**REQUEST FOR PROPOSALS FOR
GENERAL CONTRACTING SERVICES
7300 N. MERRIMAN ROAD, WESTLAND, MI 48185**

CITY OF WESTLAND – FIRE STATION #2

**ADDENDUM NO. 3
June 10, 2024**

Sheet Number: **A-510**

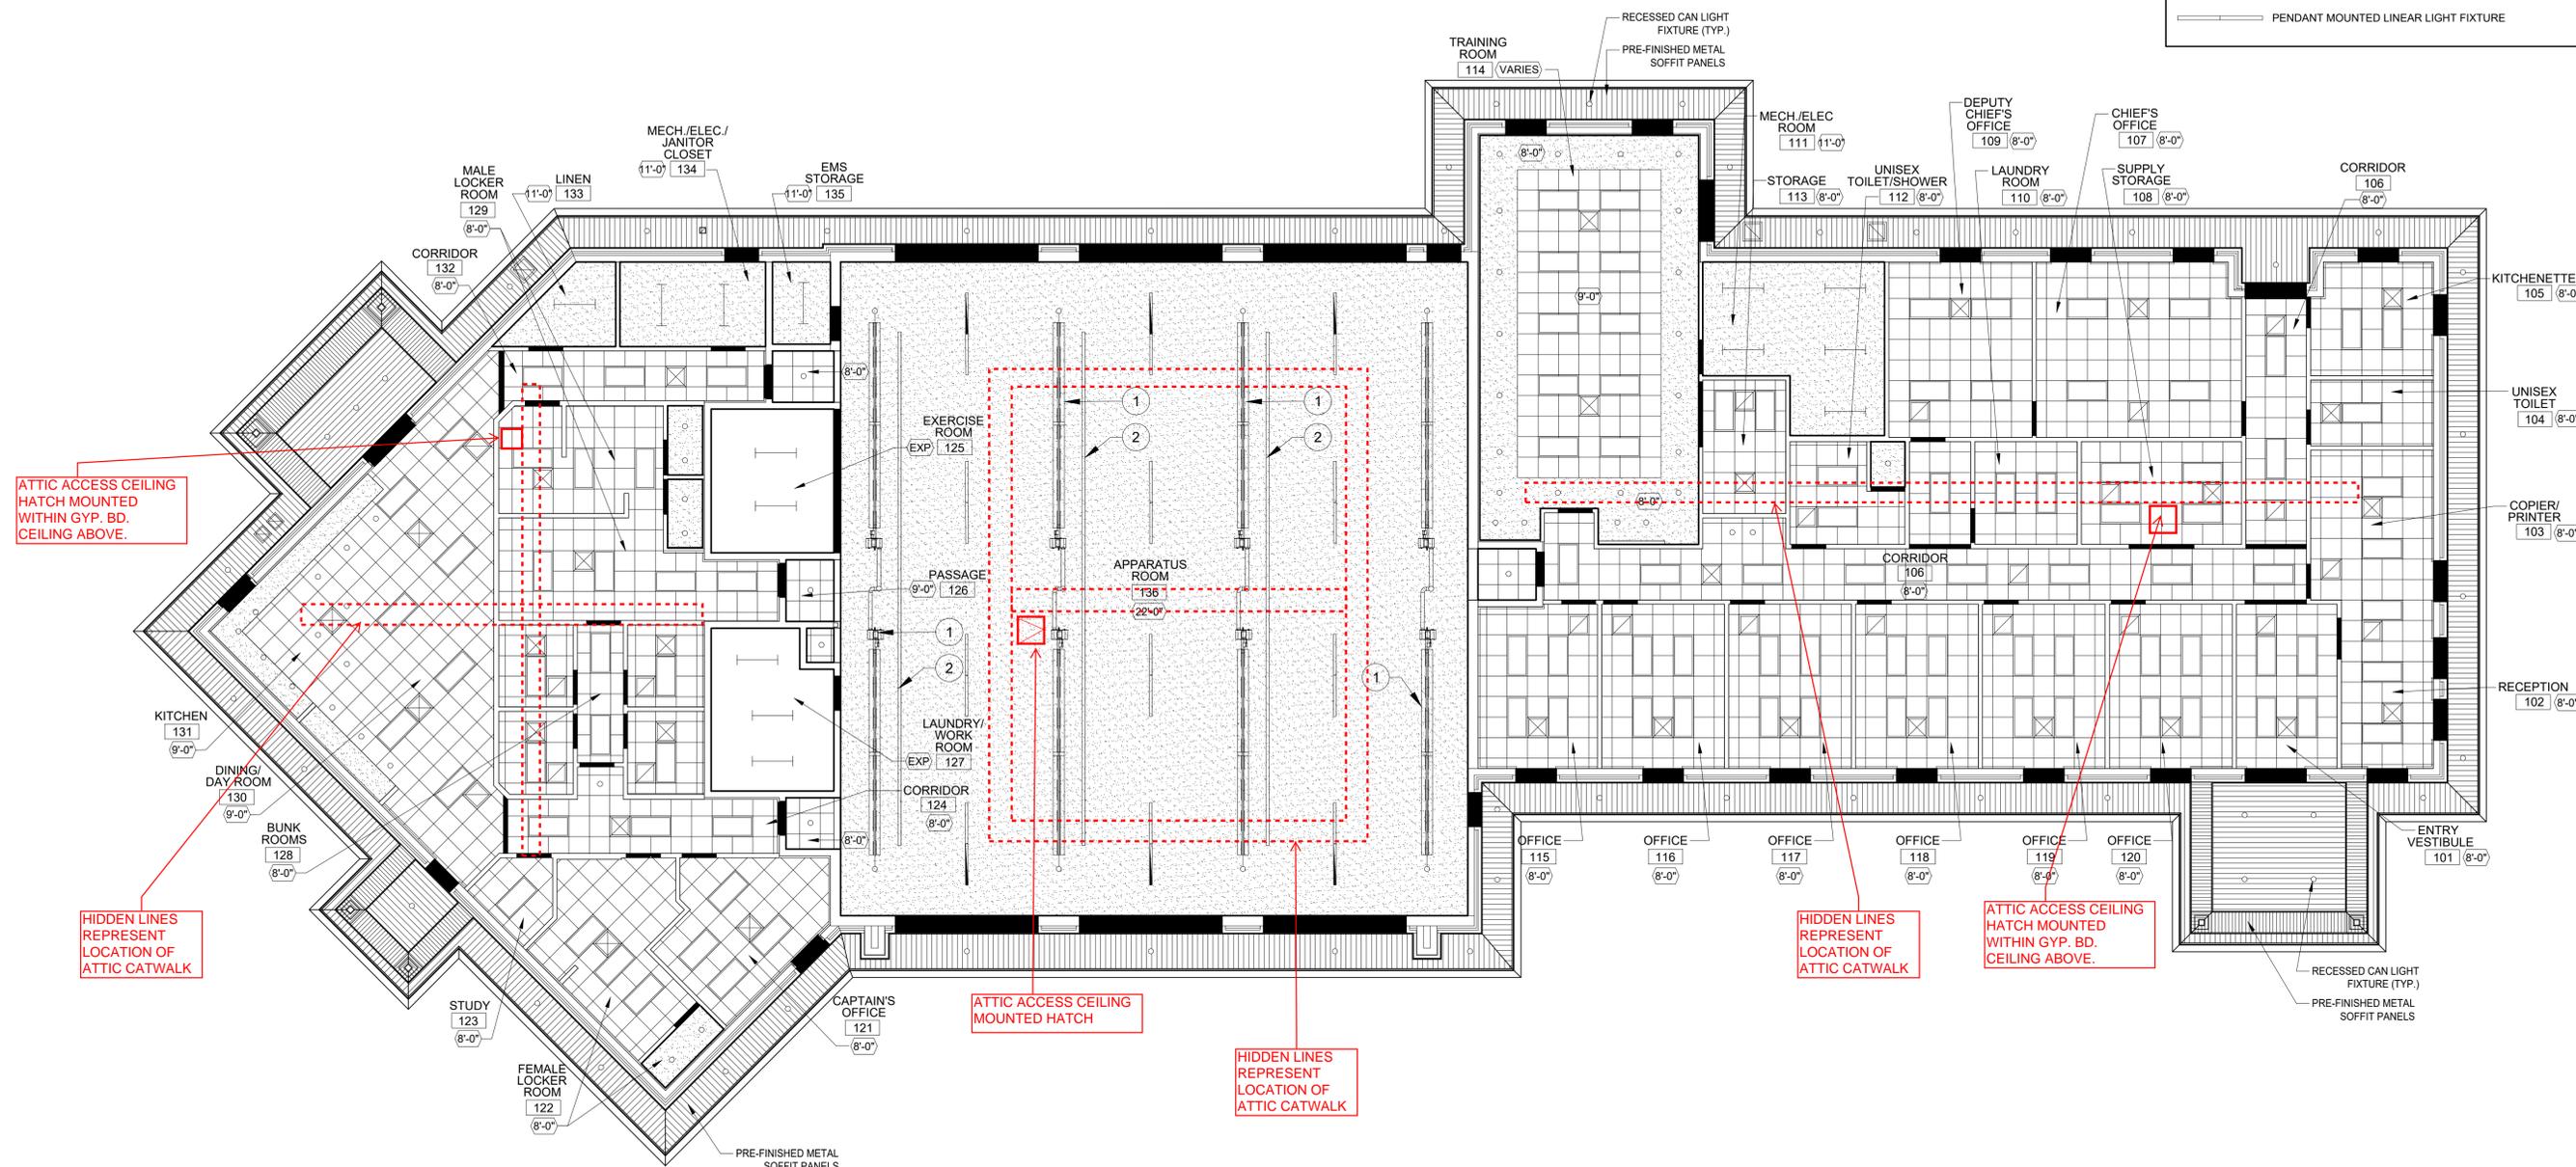
8. Cable trays, or conduit, or hooks will be addressed within the separate Cabling RFP.
- 55.** Attic access - See attached drawing A-510 for notes. The following items shall be added to the project scope. See attached 'attic access' drawing for additional information.

1. (3) ceiling mounted attic access panels/hatches. Hatches shall be located as shown on the attached plan. Hatch sizes to be 24"x24".
 2. Plywood attic 'walkway'. 'Walkway' to be located as shown on attached drawing. 'Walkway' to be constructed of $\frac{3}{4}$ " plywood shtg. (fire rated) attached to the top of the bottom truss chord. 'Walkway' to be 2'-0" wide.

ARC1 LED Architectural Wall Luminaire

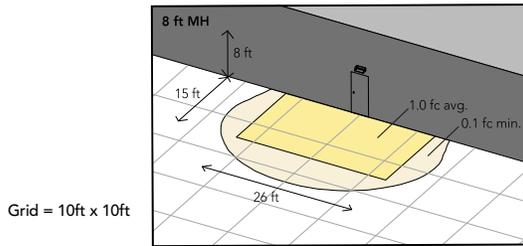
30. Q: I also don't see type "l" fixtures on the print. Please advise.
A: **Fixture 'l' shall be ignored**
31. Q: Please look into note 18 on A-201 and A-202... showing light fixtures, but I do not see them on the lighting schedule. Descriptions do not match. Please verify style and quantity.
A: **Light fixtures #18 as noted on A-201 and A-202 shall be included within the bid. See attached light fixture type to be used as basis of design (Lithonia ARC1 LED)**

Sheet Number: **S-210**

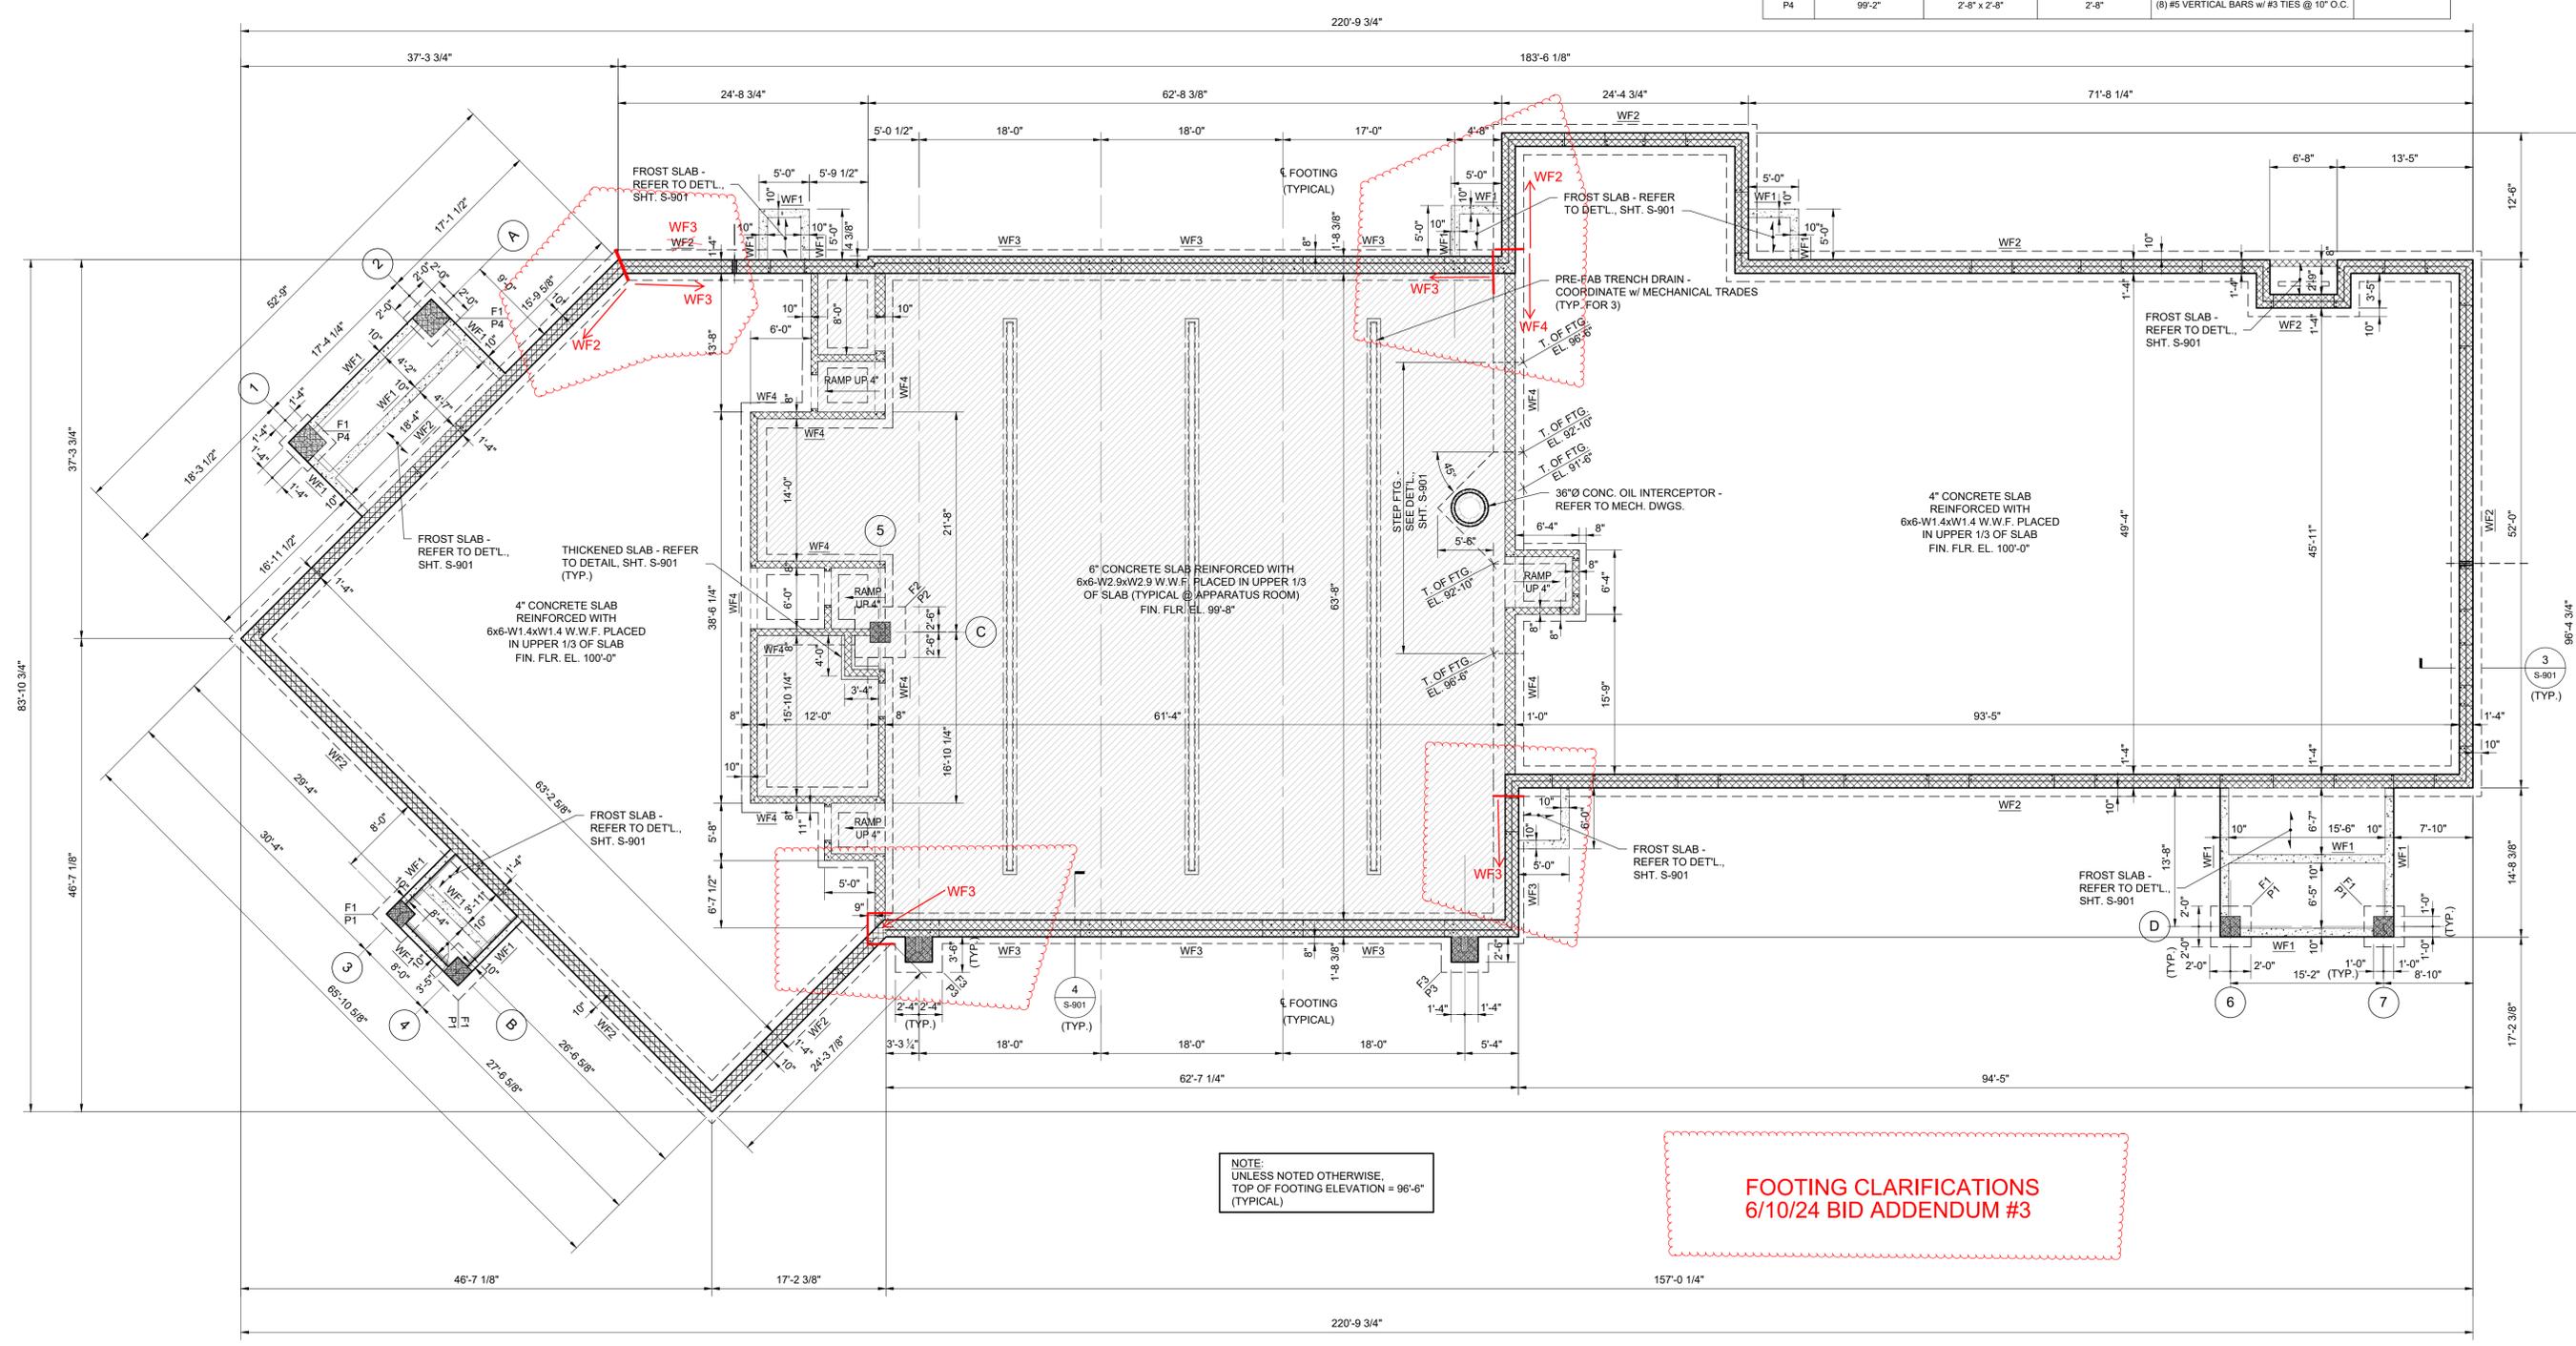
50. Q: On Page S-210 it is not clear where the footing size transitions from WF2 to WF3. When you scale it, both sizes scale to be 3', so there is nothing to tell us where one size starts/stops. Please advise.
A: **See attached drawing S-210. Clarifications are clouded and highlighted in red.**

**FOOTING CLARIFICATIONS
6/10/24 BID ADDENDUM #3**
